MBQJ-302
TECH BULLETIN

Jeep JK Template Alignment Adjustment

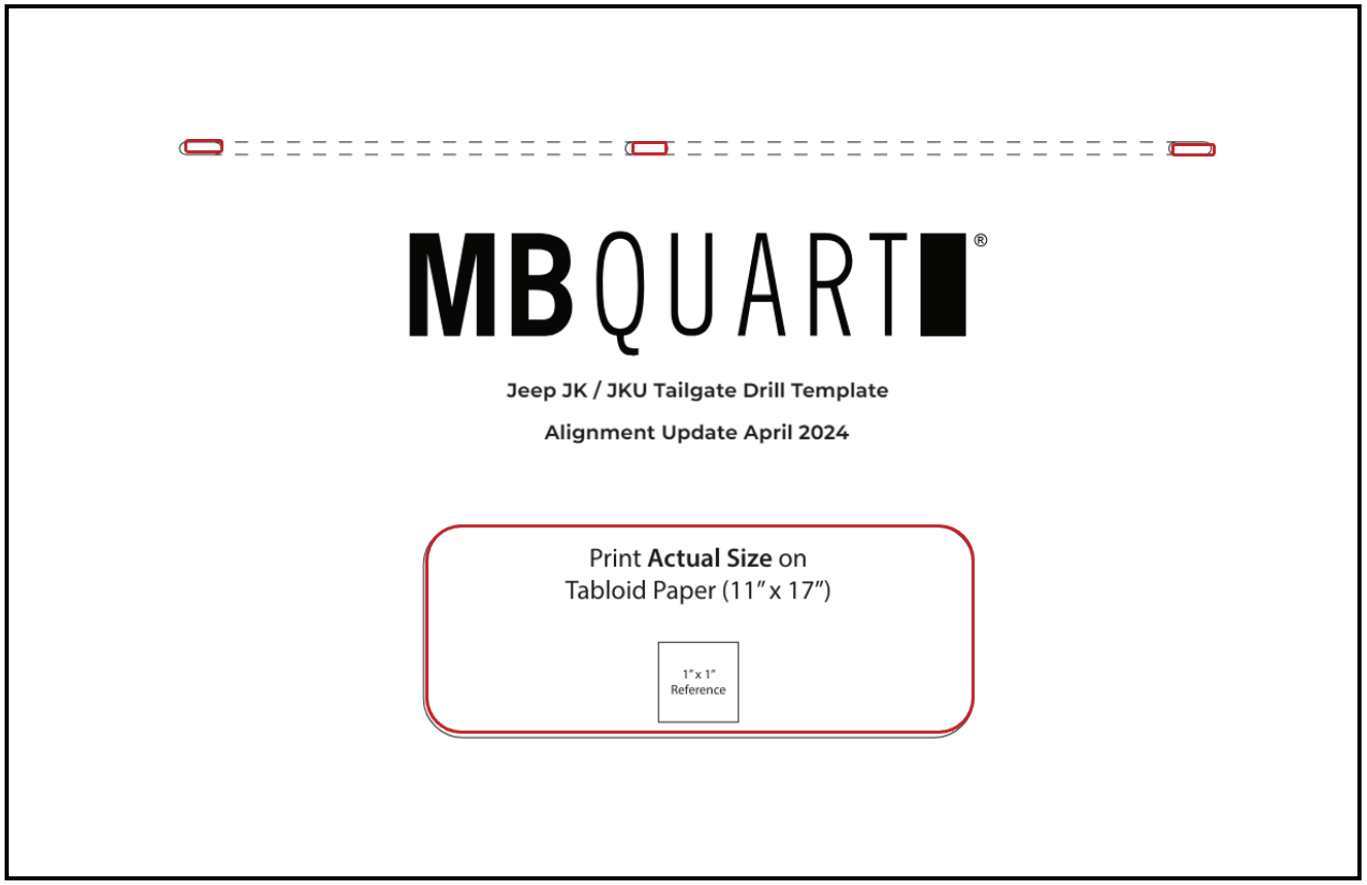
The problem: This may cause your drill holes to land on the edge of an internal brace making the hole hard to drill and your threaded insert hard to place.

The Fix: Use the updated alignment template to raise the 3 alignment markers.
